COMMITTEE OF THE WHOLE NOVEMBER 1, 2004

SITE DEVELOPMENT FILE DA.03.082

RULAND PROPERTIES INC./FIRST VAUGHAN INVESTMENTS LTD.

Site Plan

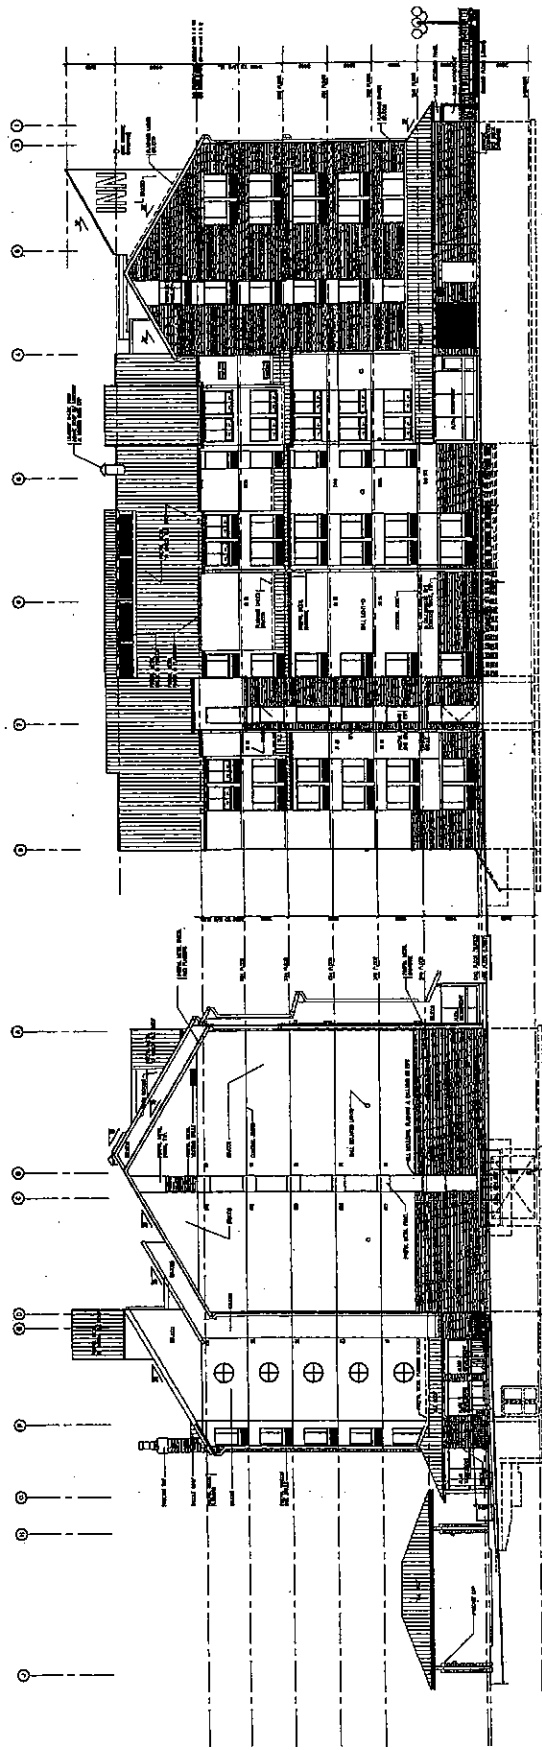
- a) 173 parking spaces are provided, whereas 193 spaces are required;

- b) a 0.0m wide landscape buffer abutting Applewood Crescent in the vicinity of the daylighting triangle, whereas a 6.0m is required;
- c) a 1.55m wide landscape buffer abutting Applewood Crescent in the vicinity of the outdoor patio, whereas a 6.0m is required.

The proposed hotel (6,324.44m²) is sited on the west side of the property, with access from two 7.5m wide driveways along the west and south property lines. Parking is provided to the north, east and south sides of the building. The proposed 3m wide landscaped buffer is maintained along the majority of Applewood Crescent, but decreases to 1.55m in the area of the outdoor patio and 0.0m in the area of the daylighting triangle. The outdoor patio is treated with interlock pavers with a low brick wall/iron fence along the perimeter to enhance the streetscape in this area. A walkway connection through the daylighting triangle provides pedestrian access from the interlocked circular driveway in front of the hotel entrance to the public sidewalk on Applewood Crescent, and creates a street-related focus at this intersection.

A basement level walkout patio amenity area is located approximately ¾ along the south side of the building. In addition, a 3.05m diameter and 3.35m high fountain is proposed in the middle of the turnaround circle. A 2m wide landscape strip is provided along the north and east property lines, together with landscaping around the perimeter of the hotel and within the parking areas.

The site is deficient by 23 parking spaces (11.9%). The Engineering Department has reviewed the site plan for this development and has no concerns with the recommended parking supply. A variance is required to accommodate the deficiency.

Staff has worked with the applicant to create an acceptable site plan and can support the required variances. The applicant will be required to obtain the variances from the Committee of Adjustment, which must be final and binding prior to the execution of the site plan agreement.

Building Elevations

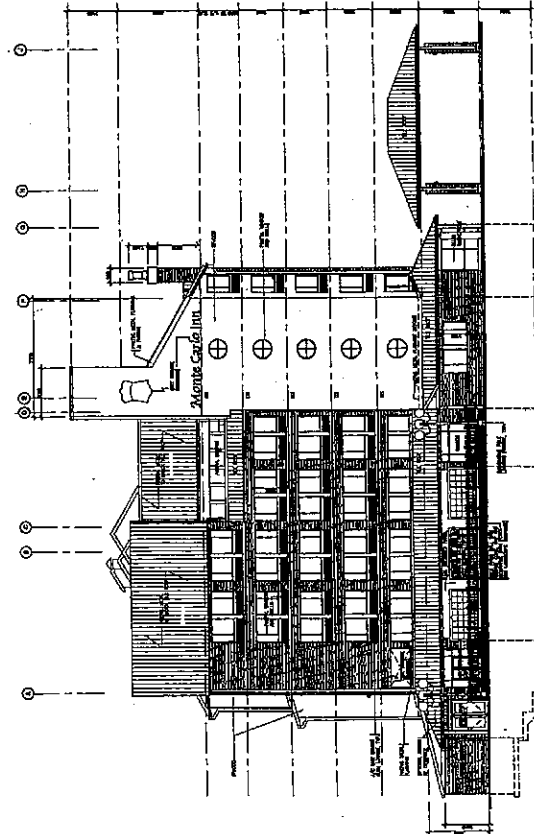
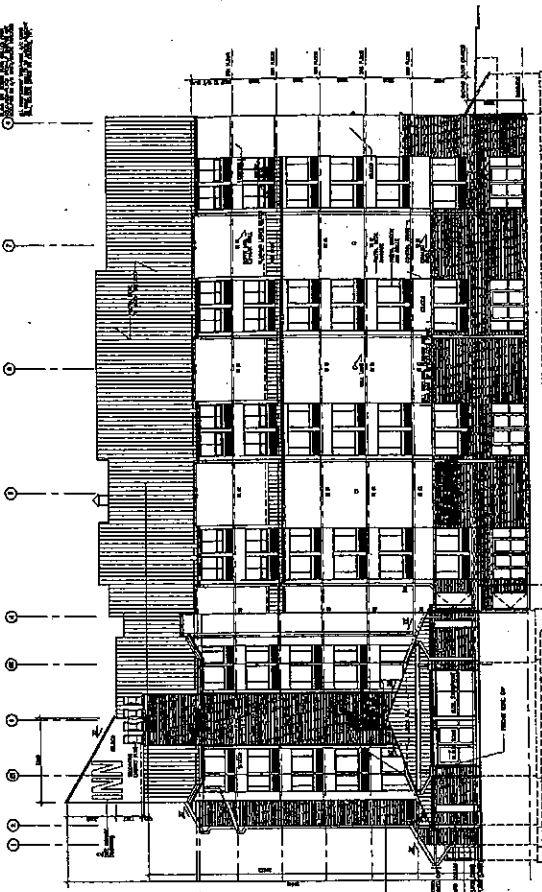
The 6-storey, building is to have a gable roof with a height of 20.4m, and increasing to 25.4m in the area of the corporate signage.

The building materials consist of a beige coloured stucco mixed with a redish-brown brick. The company signage in red, black and yellow is located on the west and south elevations (facing Applewood Crescent). The main entrance faces south and consists of sliding doors, windows and a tile roof canopy (in a colour to match the brick) over a portion of the turnaround circle. The tile roof canopy continues approximately 1/3 of the way along the east elevation, and also along the west elevation in the area of the restaurant. Sliding serving doors and three glazed overhead doors provide access to the patio area. In addition, a separate restaurant entrance is provided adjacent to the patio. A brick chimney stack with a height of 20.4m is directly above the main entrance. The brick material and decorative chimney flutes blend into the building design.

All elevations are fairly consistent. The upper roofing is in a prefinished metal to match the tile roof. Prefinished clear windows are evenly spaced along each floor representing each unit. Round windows are provided at the end of each hallway facing west and east, which adds to the architectural treatment in the vicinity of the signage tower and storefront. In addition, an overhead door is located on the north elevation for access to the internal garbage room.

Staff is satisfied with the proposed building elevations.
